POOP DECK
MAIN DECK
MAIN DECK
FOCSLE DECK
MAIN DECK
GENERAL NOTES
ABBREVIATIONS
PHILADELPHIA NAVY YARD
INDUSTRIAL DEPARTMENT
HULL PLAN
ACCESS
MAIN DECK
COMPARTMENT 6 ACCESS
BUREAU OF SHIPS PLAN NUMBER
AGC7-S(G)I-485192 ALT 1

TITLE
ACCESS
2nd DECK
COMP. & ACCESS

BUREAU OF SHIPS PLAN NUMBER
AGC7-S1601-489191 ALT. 4.

TITLE
ACCESS
2ND PLATFORM
COMPARTMENT & ACCESS

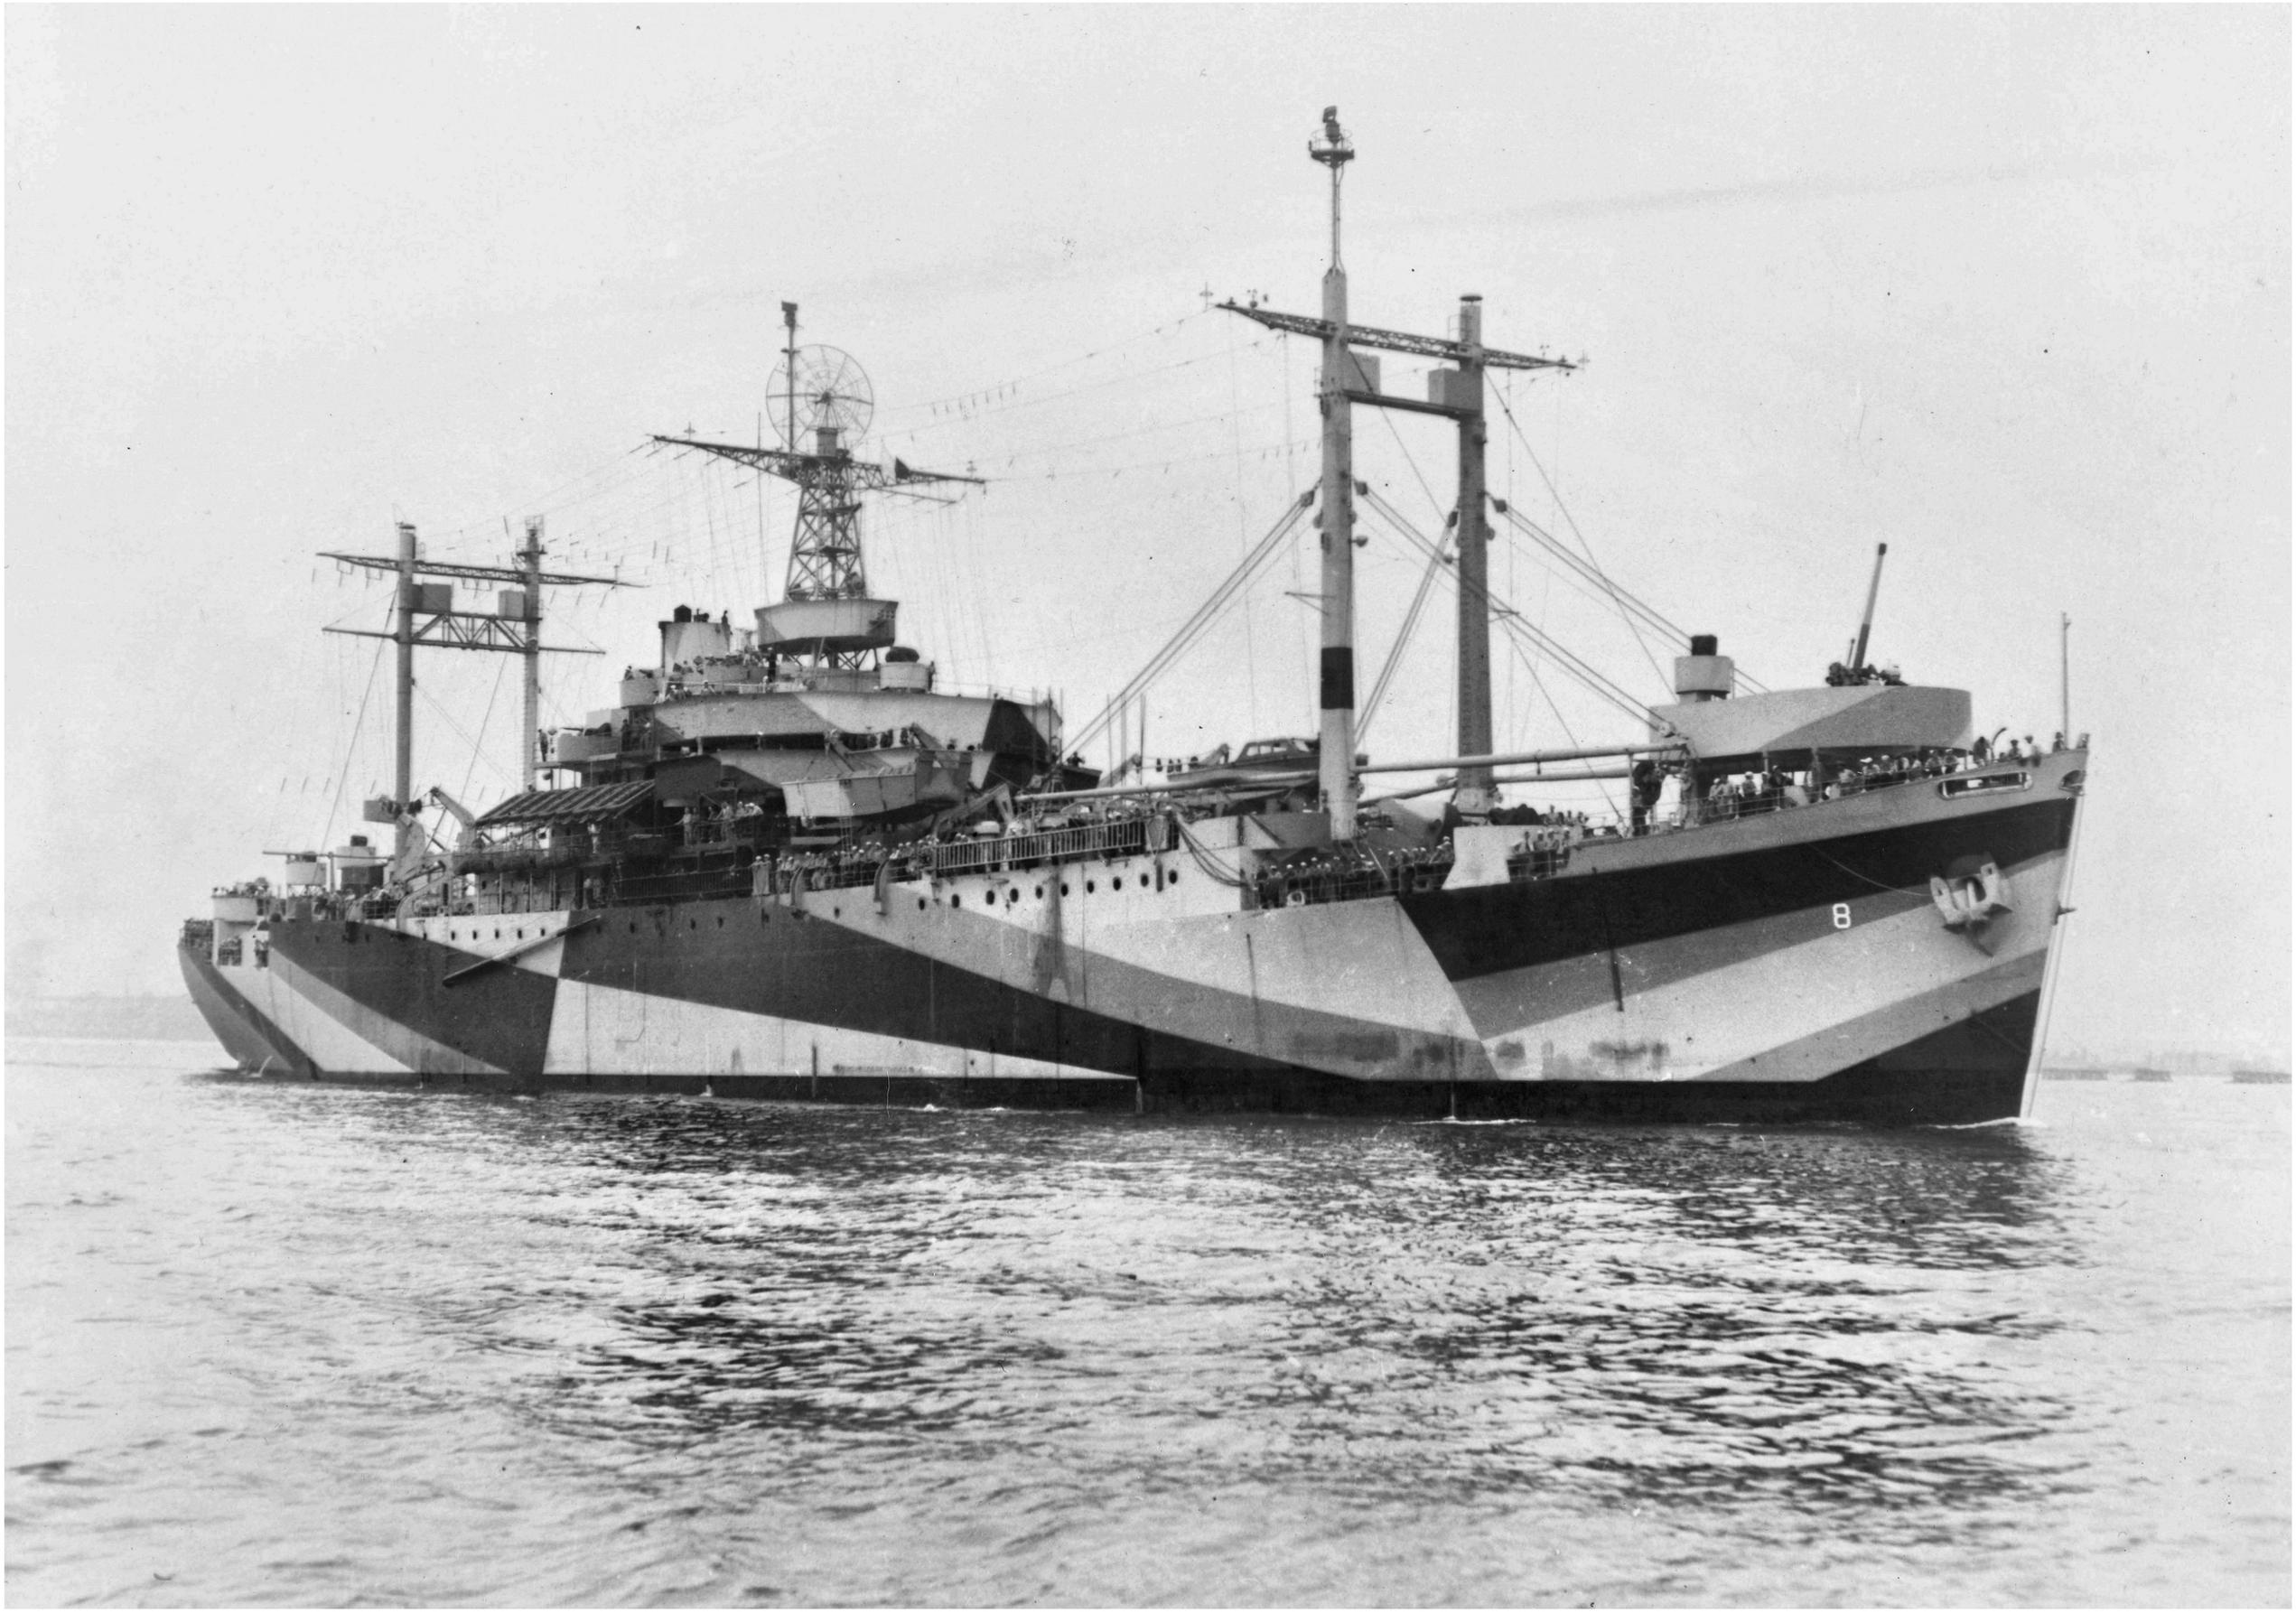
No	PANEL No	DESCRIPTION	APPROVED	DATE	D/M AFFECT
2.	3.	€ LONG. M.J. BHD. & LONG M.J. BHD 12'6" OFF € FR 38-41 CHANGED TO N.T. TRANS M.J. BHD FR 38.5 CHANGED TO N.T.			
	3.	26"x68" F.B.M.J. DOOR 18" AFT FR 38.3 12'6" OFF € RELOCATED TO 10'0" OFF € &			
	3	26"x74½" S.P.M.J. DOOR 8'6" OFF € & FR 38 ADDED.	[signature]	2/20/44	
3	8.	KINGPOSTS FR 141 12'6" OFF € P/S MODIFIED			
	7	LONG'T N.T. BHD. FR 165 P. MODIFIED & TRANS N.T. BHD FR 165-166½ 16'7" OFF € ADDED.			
	7.	EXP. M. BHDS. FOR ICE CREAM MACH. RM. FR 129 TO 18'9" AFT FR 132-P. MODIFIED.	[signature]	3/1/44	
	4.	CHAPLAINS OFFICE FR 51-54 P. 3'9" OFF € ADDED TO PLAN.			
	3	TRANS. N.T. BHD. FR 30 FROM € TO 10'0" OFF € P/S CHANGED TO F.T.			
	5	M.J. DOOR 12" FWD FR 69 INTERCHANGED WITH M.J. DOOR 12" AFT FR 75-20'0" OFF € PORT ONLY.			
4	6	H-2-100 ADDED TO PLAN & TRUNK UNDER INDICATED.	[signature]	4/13/44

NO	PANEL No	DESCRIPTION	APPROVED	DATE	D/M AFFECT
1	2	LAMP ROOM FWD FR 17-P. WITH 26"x66" FLAME TIGHT DOOR. D-2-9 ADDED			
	6.	TWO 18"x18" M.J. WINDOWS IN FINANCIAL OFFICE RELOCATED FROM 6' TO 15' AFT FR 101-P. & FROM 6' TO 15' FWD FR 112-P.			
	7	D-2-114 DELETED & REPLACED BY 30"x71" E.M. DOOR 4" SILL			
	7	LONG'T E.M. BHD 15'0" € 16'6" OFF € FRS 113-118-S DELETED & REPLACED BY N.T. BHD.			
	7	D-2-118 ADDED.			
	7	30"x75" E.M. DOOR 17" FWD FR 126-S 14'3" OFF € CHANGED TO 30"x71" E.M. DOOR-4" SILL WITH INSECT SCREEN.			
	7	3'0"x3'0" N.T. SHUTTER ADDED.			
	8	SWING OF D-2-132 CHANGED & No. CHANGED TO D-2-131.	[signature]	4/10/44	
	7	INSECT SCREEN ADDED TO EXP. M. SHUTTER OVER STEAM TABLES IN CREWS GALLEY FR 118-125 P/S. INSECT SCREEN ADDED TO EXP. M. BHD. FR 115-118-P.			
	6	D-2-103 RELOCATED & DOOR No. CHANGED TO D-2-102			
	5	SILLS OF THE FOLLOWING M.J. DOOR CHANGED FROM ¾" TO ½": FR 76-8'0" OFF € & 7'4" OFF € P-18" FWD FR 78 9'0" OFF € S-7" FWD FR 78-20'0" OFF € - 4'AFT FR 83 € - FR 89-11'4" OFF € - ABT 24" FWD FR 58 AB-14'0" OFF € - 24" AFT FR 94-17'0" OFF €

5	DOOR SIZE OF DOORS AT 12" FWD FR 78, 8'0" OFF € P/S & FR 79 14'0" OFF € P/S CHANGED FROM 71" TO 71½"			
	9	4" OD STANS 15" FWD FR 166-14'0" € 10'0" OFF € P/S & 15" FWD FR 168 P/S 14'0" OFF € DELETED.			
	5	RECESS IN TRANS BHD 15'0" OFF € P. AFT SIDE FR 66 CHANGED FROM 3'0" TO 4'0"

2.	9.	LOCATION OF D-2-176-4 CHANGED FROM 3" AFT FR 177 TO 2" AFT FR 177.			
	7.	SWING OF D-2-118 CHANGED FROM OUTBD & AFT TO INBD & AFT.			
	6.	TRANS. M.J. BHD. 21'0" OFF € FR 100 P. CHANGED TO N.T.			
	3 6	THE FOLLOWING F.T.M.J. CHANGED TO F.T.: TRANS. BHD FR 30 10'0" OFF € P/S. TRANS. BHD. FR 57-20'0" OFF € P/S.			
	5 6	LONG'T BHD. 20'0" OFF € FR 81-90-P ONLY. TRANS. BHD. 18" AFT FR 89 20'0" OFF € P.			
	6	SWING OF E.M.D. 14½" FWD FR 102 21'0" OFF € CHANGED. DIM. OFF € FOR HATCHWAY 24" AFT FR 41 P CHANGED FROM 13'0" TO 13'6" OFF € P.

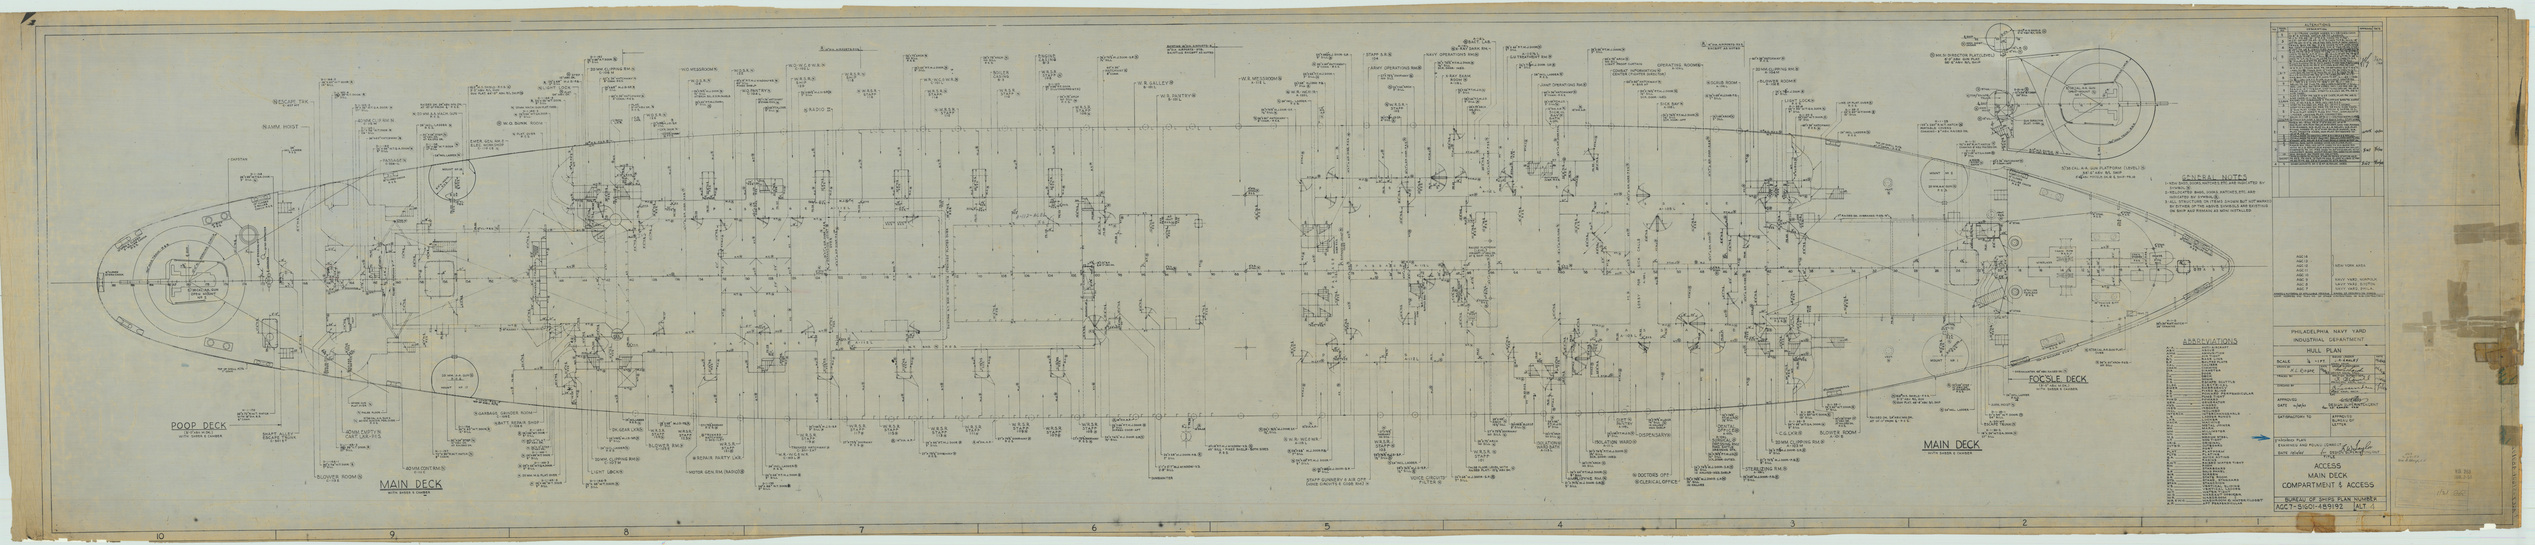
ALTERATIONS					
NO.	PANEL NO.	DESCRIPTION	APPROVED	DATE	B.S. APPR'D.
1	8,9,10 / 3,5,7, / 8,9,10	4" W.T. COAMING INSTALLED UNDER EXP. MET. BHDS ENCLOSING MAIN ISSUE RM. & S.D. STORES FRS. 129-132 P&S AND S.D. STORES, FRS. 145-155 P&S. EXP. MET. DOORS CHANGED TO SUIT. ALL M.H. OVER ADDED. GIRDERS OVER BETWEEN FRS. 129-170 ADDED. MANHOLE (M-4-141) RELOCATED	HJG	1/13/44	
2	5	NEW DOOR ADDED ON FR. 69, 26'-9" OFF ℄ PORT. CENTERLINE OF OPENING FOR CAMERA RELOCATED TO 24'-0" OFF ℄ PORT ON BHD. 69. DOOR LOCATED AT 21" FWD OF FR. 69 & 19'-6" OFF ℄ PORT CHANGED IN SWING FROM OUTBD. & AFT. TO INBD. AND FWD.	FWJ	2/16/44	
3	4	BHD. ON FR. 39 STBD. RELOCATED TO 10" FWD. OF FR. 39. BHD. 9'-11" STBD OFF ℄ BETWEEN FRS. 39-41 & BHD. 10" FWD OF FR. 39 S CHANGED FROM F.T.M.J. TO N.T. BHD.	FWJ	4/15/44
